DOCKET ITEM #11
Master Plan Amendment #2017-0004
Text Amendment #2017-0006
CDD Concept Plan #2017-0001
Development Special Use Permit #2016-0022
Potomac Yard Landbay H/I East Multifamily
2551 Main Line Boulevard

Application	General Data	
Project Name: Potomac Yard Landbay H/I East Multifamily	PC Hearing:	October 3, 2017
	CC Hearing:	October 14, 2017
	If approved, DSP Expiration:	October 14, 2020 (three years)
	Plan Acreage:	53,709 SF (1.23 acres)
Location: 2551 Main Line Boulevard	Zone:	CDD #10 / Coordinated Development District #10
	Proposed Use:	Multifamily Residential
	Dwelling Units:	72 (Building 1) + 70 (Building 2) = 142 total units
	Net Floor Area:	95,557 SF (Building 1) + 93,645 SF (Building 2) = 189,202 SF total
	Small Area Plan:	Potomac Yard/Potomac Greens

Master Plan Amendment #2017-0004
Text Amendment #2017-0006
Coordinated Development District Concept Plan #2017-0001
Development Special Use Permit #2016-0022
2551 Main Line Boulevard

Graphic A: Height-to-Setback Ratio Exhibit

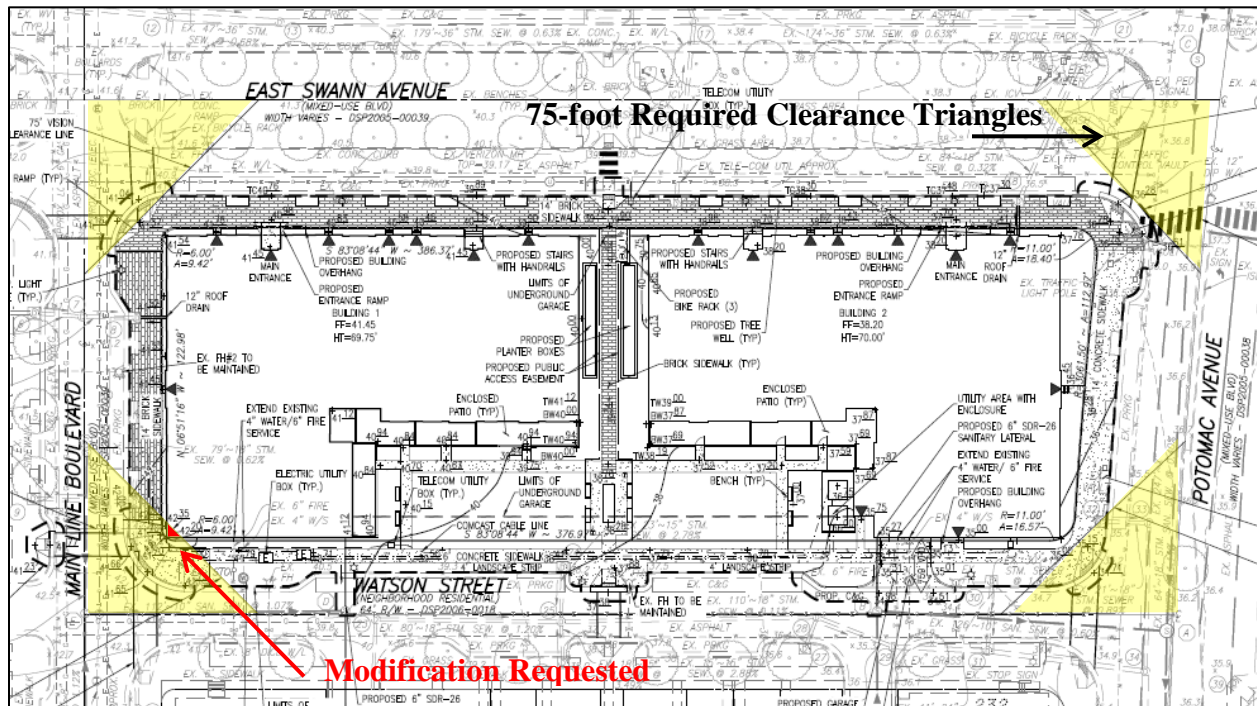
Both of the requested modifications are desirable in this instance. The modification of the vision clearance requirement is slight at only six feet less than required and would occur only at one of four intersections around the site (Main Line Boulevard and Watson Street). The height-to-setback requirement modification is also modest: in two instances it represents about five feet of additional height compared to the setback provided (or, vice versa, about 2.5 feet of reduced setbacks compared to the height provided) and in the third instance it amounts to less than one foot of additional height. In addition, it has only been requested at three of the six instances in which the requirement applies. Ultimately, staff believes the modifications are desirable given that they bring the proposed buildings closer to the street, supporting the creation of a streetwall consistent with the urban development pattern broadly recommended in the Small Area Plan. Both modifications have often been modified in Potomac Yard to create more urbane buildings.

The intersection of Main Line Boulevard and Watson Street has already been constructed with curb and gutter as part of area-wide road infrastructure improvements at Potomac Yard. The parking lane on Watson Street is tucked behind the area at which a new curb ramp will be constructed, forming an area that functions as a bump-out to bring pedestrians closer to the intersection for greater visibility and safety. This design feature would mitigate any minimal impact from the

reduced vision clearance requirement. With regard to the height-to-setback requirement, the building has been designed in such a way that only relatively short portions of the building (the short end of the “L”) would need to be modified in two instances, thereby reducing the extent of the request and mitigating any negligible impact from the reduced height-to-setback ratio. Ground-level open space at the site, particularly adjacent to Watson Street, also mitigates the requested height.

Graphic 1 – Revised Site Plan

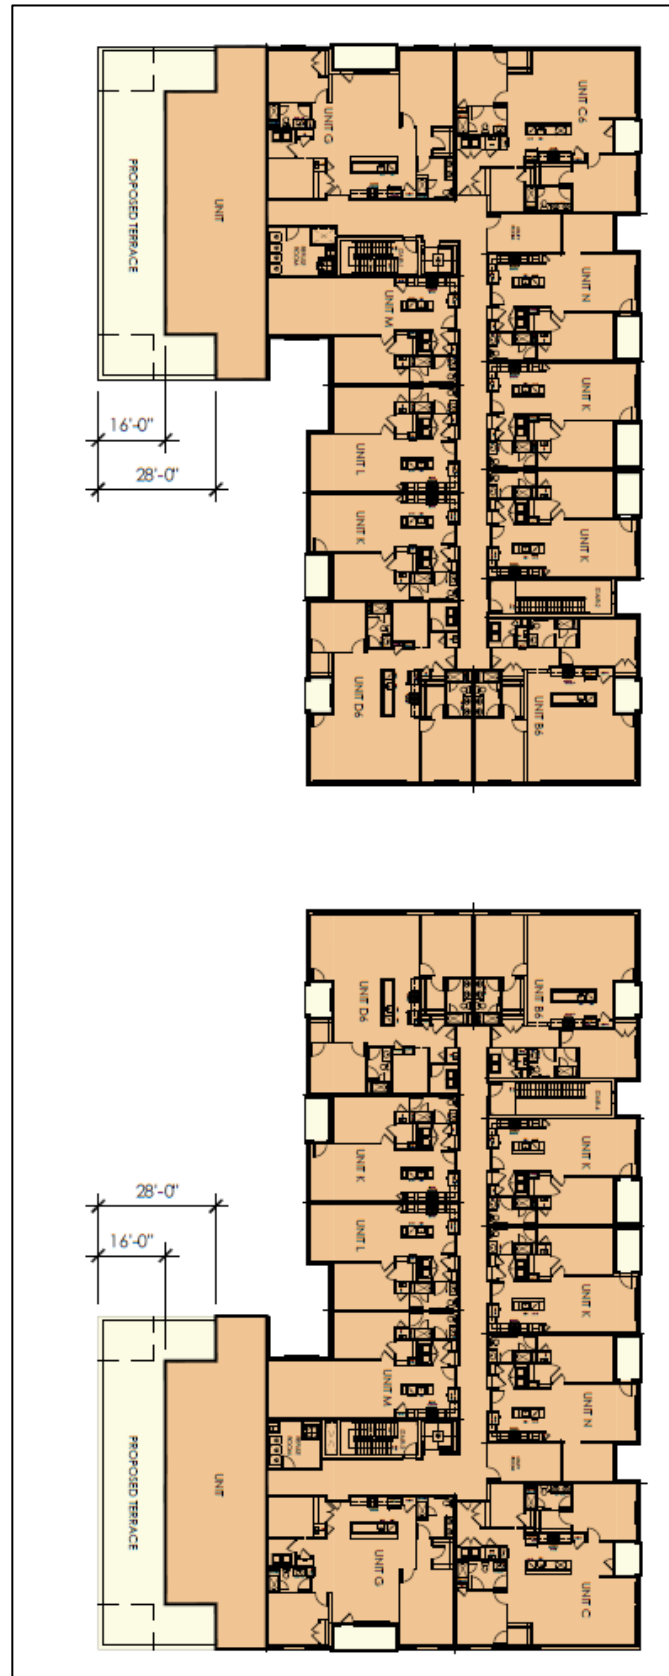
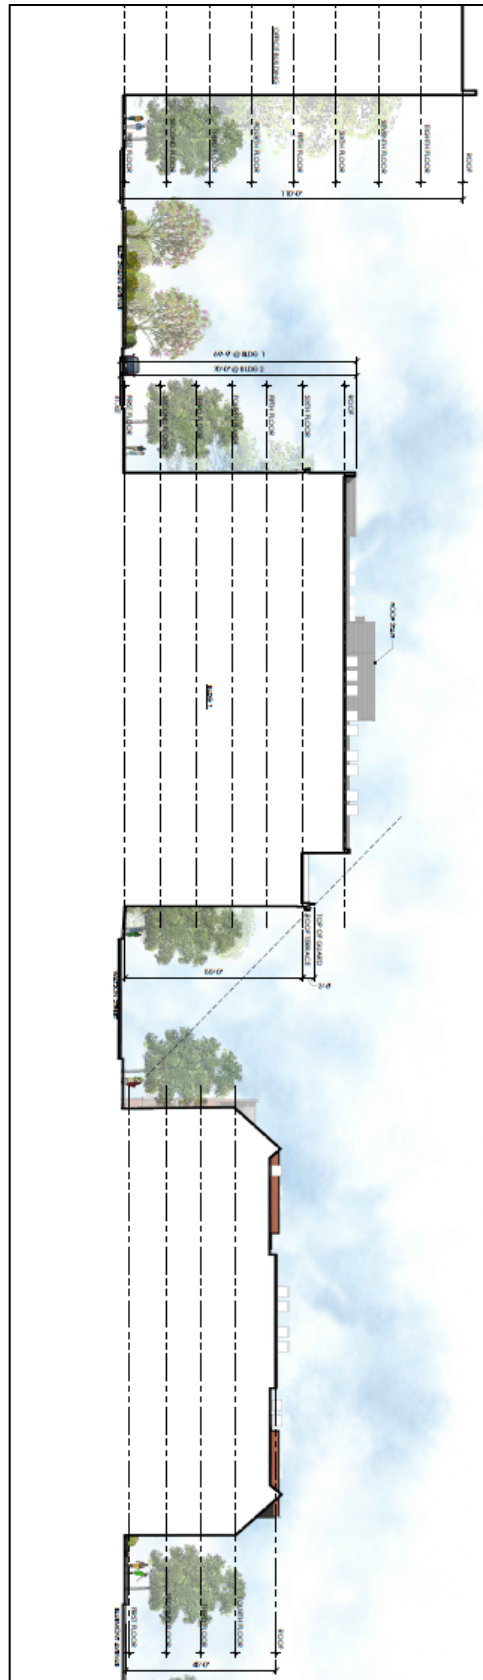
September 20th meeting. The first of the recommendations was to increase the apparent height of the first floor as it felt out of proportion with the rest of the building. The architect achieved this change by increasing vertically the amount of the rusticated beige brick up to the window sill of the second floor which visually creates a stronger base. Similarly the Committee recommended that the apparent height of the top floor be reduced as it appeared too tall and out of proportion with the rest of the building. Again the architect was able to do this by increasing the vertical dimension of the fifth floor cornice and frieze. Finally, PYDAC members also agreed with staff to create a stronger sense of entry. This was achieved by creating a vertical band framing the entry and extending it through to the top floor. This made a significant difference and provided the added benefit of creating additional visual interest to the Swann Avenue facades.

In addition to responding to the design recommendations noted above, the applicant introduced a building design revision to the southern facades of each building at the September PYDAC meeting. The revision creates a step back at the sixth floor at the end of the “ells” of the building. The intent of the step back is to create a more gradual transition between the two buildings and the four story townhouses located to the south. This revision results in a reduction of one dwelling unit from each building. This two unit reduction would not change the total parking count nor the number of units set aside as affordable housing units. These revisions along with an email from the applicant describing this change are attached to this report as *attachment #7*.
